SI0299

Equipment Affected: OptiView Control Panel Retrofit Kits for YT and YK Chillers

VSD Modbus Comms Upgrade for OptiView Control Panel Retrofit Kits

FIGURE 1 - 035-21565-000 FOR MODEL VSD DRIVES

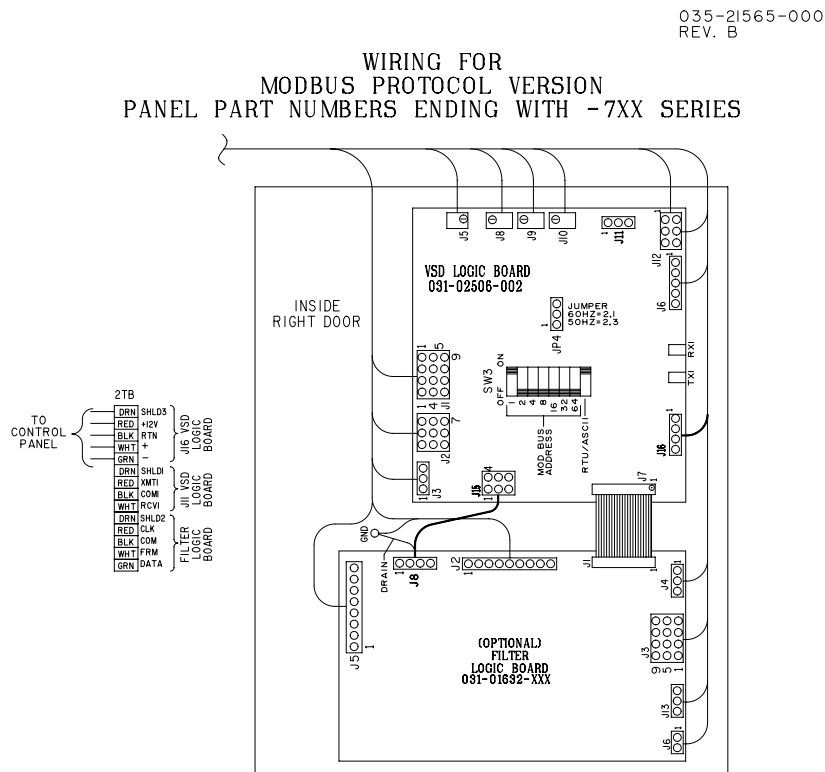
1. VSD logic bd. J11 unplugged
2. VSD logic bd. J16 plugged in
3. VSD logic bd. J15 plugged into J8 of filter logic bd. remove small cable attached to main harness for this connection.
4. VSD logic bd. SW3 positions I and RTU/ASCII on. All other positions off.
5. VSD logic bd. JP4 60hz or 50 hz appropriately for application.

FIGURE 2 - 035-21563-000 FOR MODEL TM-3 DRIVES

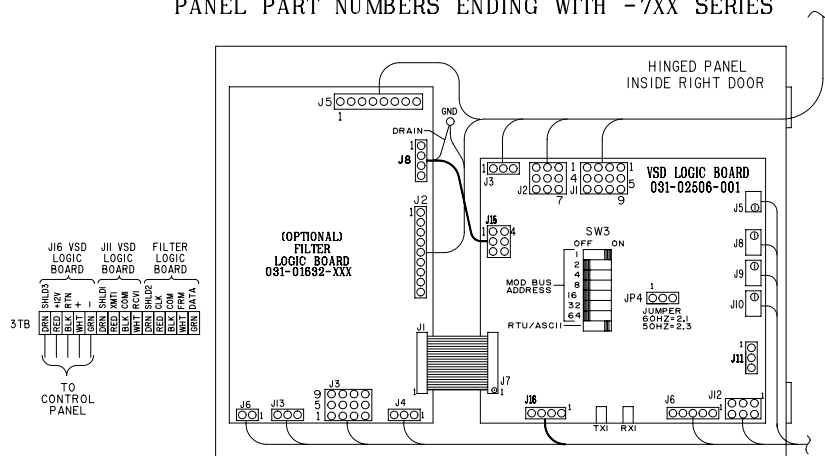
1. VSD logic bd. J11 unplugged
2. VSD logic bd. J16 plugged in
3. VSD logic bd. J15 plugged into J8 of filter logic bd. remove small cable attached to main harness for this connection.
4. VSD logic bd. SW3 positions I and RTU/ASCII on. All other positions off.
5. VSD logic bd. JP4 60hz or 50 hz appropriately for application.
